Addendum 94 – UN Regulation No. 95

Revision 4 - Amendment 5

06 series of amendments – Date of entry into force: 15 June 2024.

Uniform provisions concerning the approval of vehicles with regard to the protection of the occupants in the event of a lateral collision

Model A
 (See paragraph 4.5. of this Regulation)

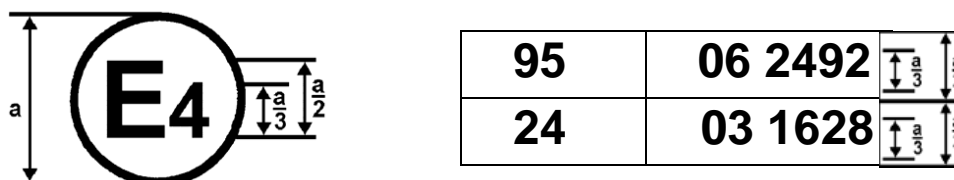
Annex 2, amend to read:

The above approval mark affixed to a vehicle shows that the vehicle type concerned has, with regard to the protection of the occupants in the event of a lateral collision, been approved in the Netherlands (E 4) pursuant to UN Regulation No. 95 under approval number 061424. The approval number indicates that the approval was granted in accordance with the requirements of UN Regulation No. 95 as amended by the 06 series of amendments.

Figure 2a
 Blocks 1 and 3

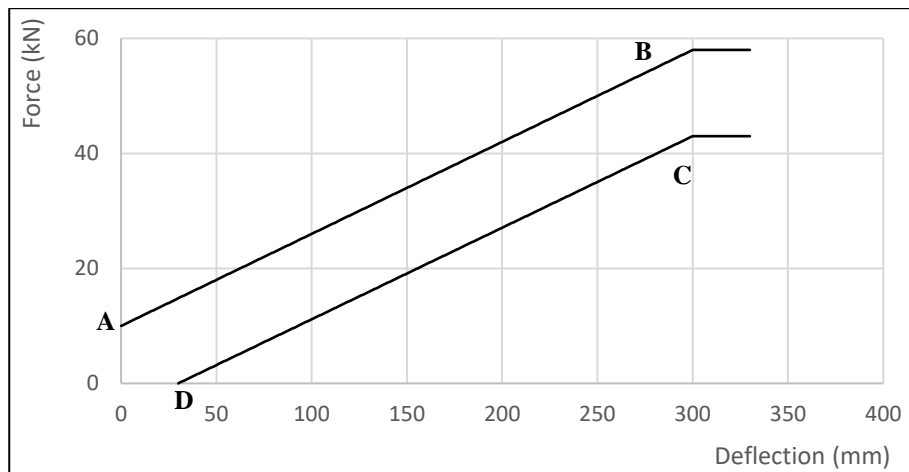
Annex 5 – Appendix 2, amend to read:

Deflection	Force
A	0 mm	10 kN
B	300 mm	58 kN
C	300 mm	43 kN
D	30 mm	0 kN

Figure 2b
 Block 2

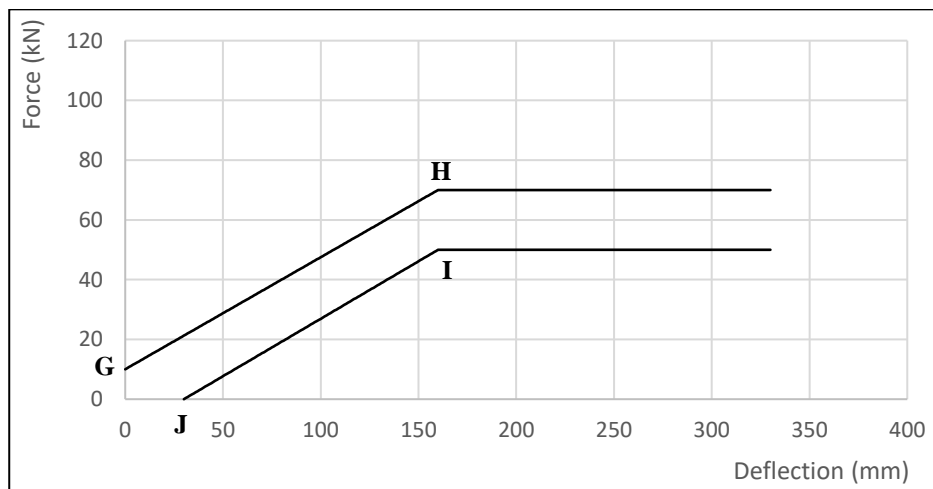
Deflection	Force
G	0 mm	10 kN
H	160 mm	70 kN
I	160 mm	50 kN
J	30 mm	0 kN

Figure 2c
 Block 4

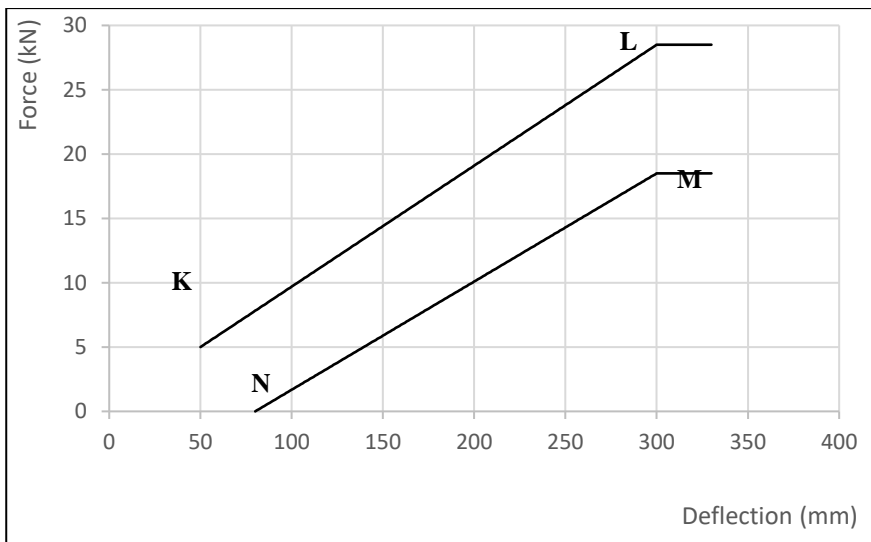
Deflection	Force
K	50 mm	5,0 kN
L	300 mm	28,5 kN
M	300 mm	18,5 kN
N	80 mm	0 kN

Figure 2d
Blocks 5 and 6

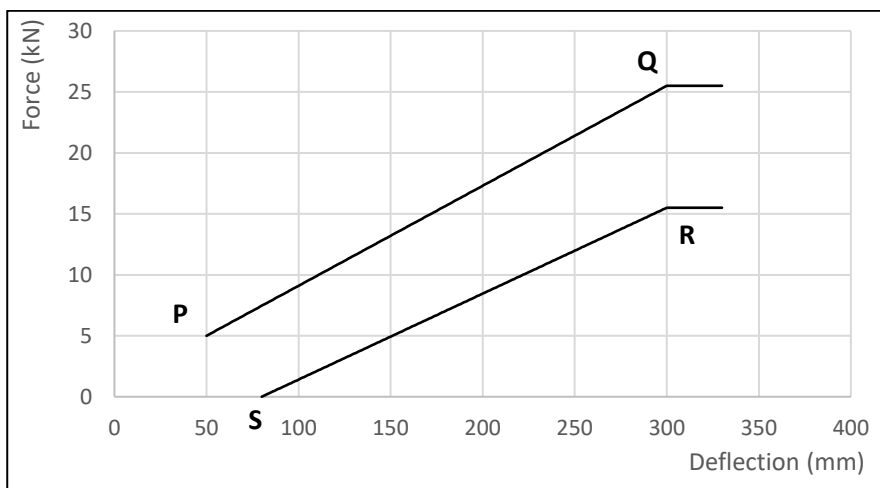
Deflection	Force
P	50 mm	5,0 kN
Q	300 mm	25,5 kN
R	300 mm	15,5 kN
S	80 mm	0 kN

Figure 2e
Blocks total

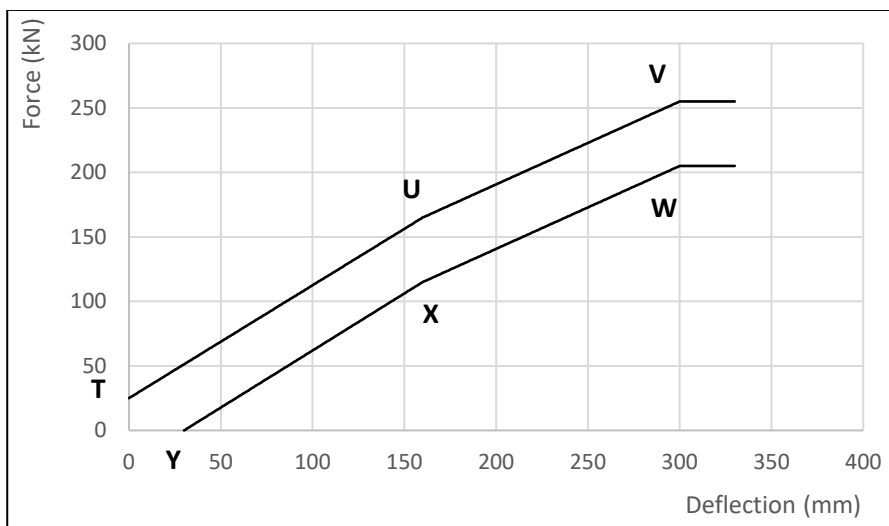
Deflection	Force
T	0 mm	25 kN
U	160 mm	165 kN
V	300 mm	255 kN
W	300 mm	205 kN
X	160 mm	115 kN
Y	30 mm	0 kN
